STAFF REPORT ACTION REQUIRED

Request for a Fence Exemption – 95 Stuart Avenue

Date:	April 13, 2016
To:	North York Community Council
From:	Pat Burke, District Manager Municipal Licensing & Standards, North District
Wards:	Ward 23 - Willowdale
Reference Number:	IBMS No. 16-126553

DRAWING: POOL PERMIT v1
DATE: JUNE 10, 2015
SCALE 1 : 150
ALL DIMENSIONS IN METERS

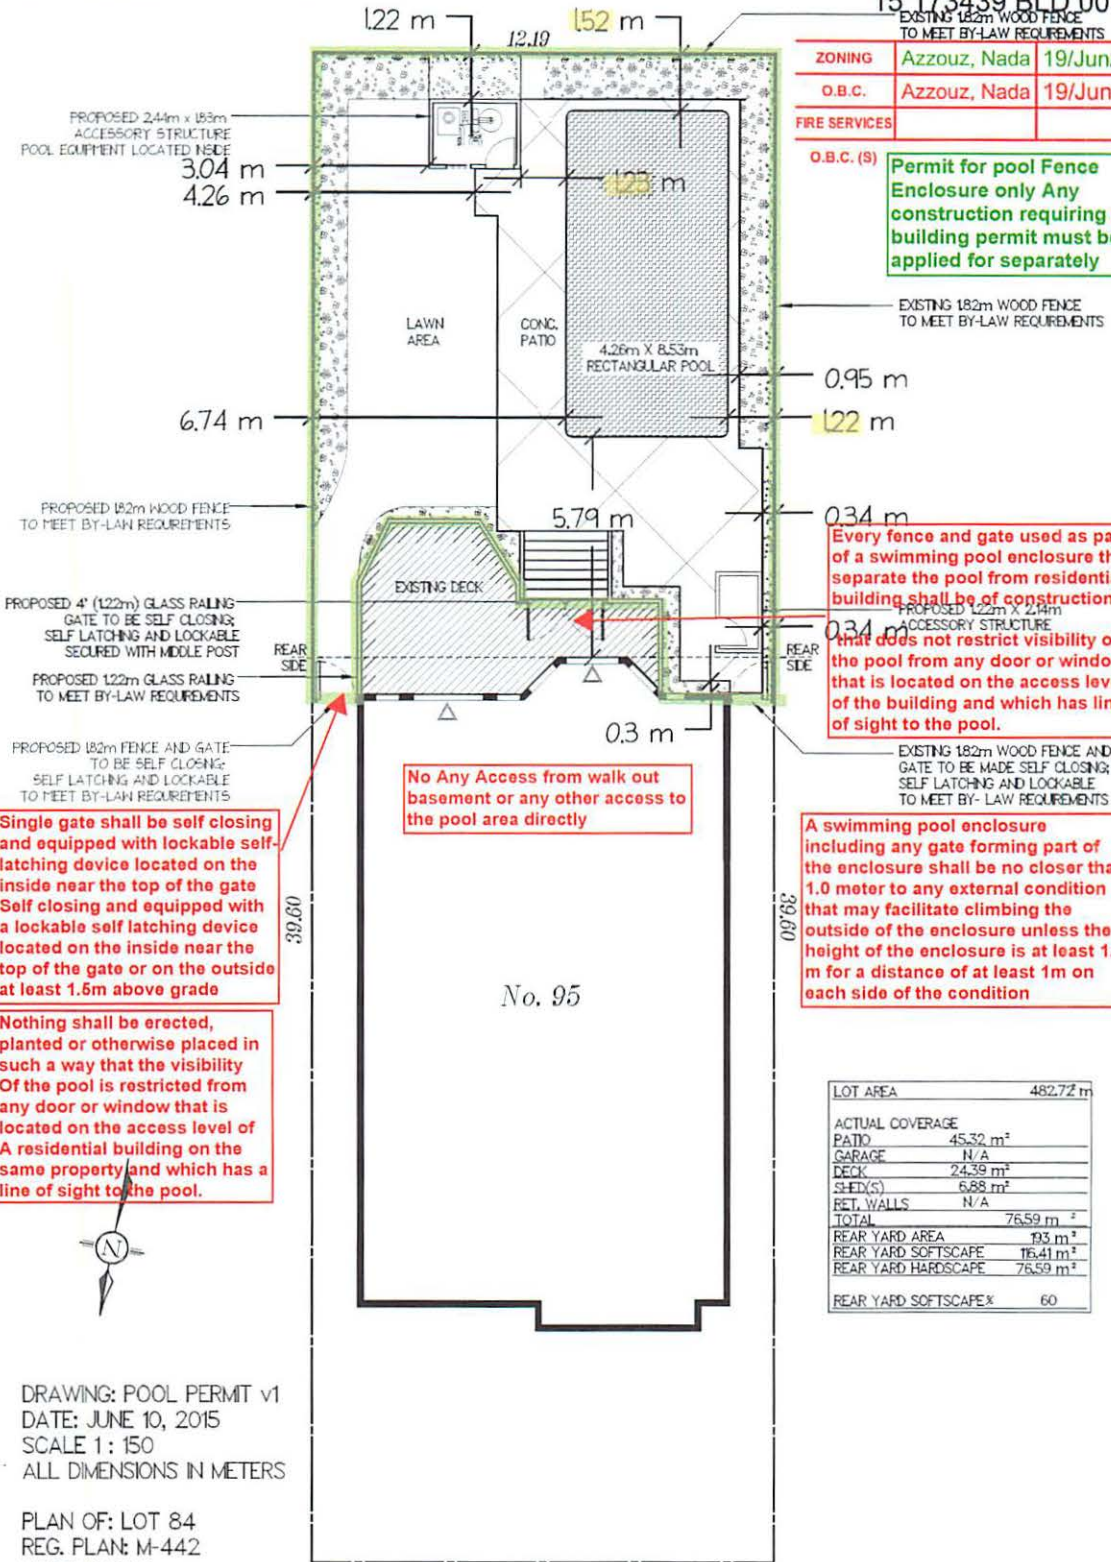
On June 19, 2015, a permit was issued under File # 15-173439 to permit the installation of a swimming pool enclosure in compliance with Chapter 447(*Attachment # 2*). This permit approved 1.82 metre high wood fences around the perimeter of the rear lot/yard at the west, east and south elevations and other fence features so as to comply with the regulations for swimming pool enclosures found in Chapter 447 - Fences. The site remains under construction with work on the pool and enclosure not completed at time of filing.

The property owner is proposing that in lieu of complying with the deficiencies noted in the chart above and that are contrary to the by-law and the issued permit under file # 15-173439, that the existing horizontal board fence profile at the west elevation be permitted, instead. (*Attachments # 3, 4, 5, 6,*)

EXISTING 182m WOOD FENCE
TO MEET BY-LAW REQUIREMENTS

EXISTING 182m WOOD FENCE AND
GATE TO BE MADE SELF CLOSING;
SELF LATCHING AND LOCKABLE
TO MEET BY-LAW REQUIREMENTS
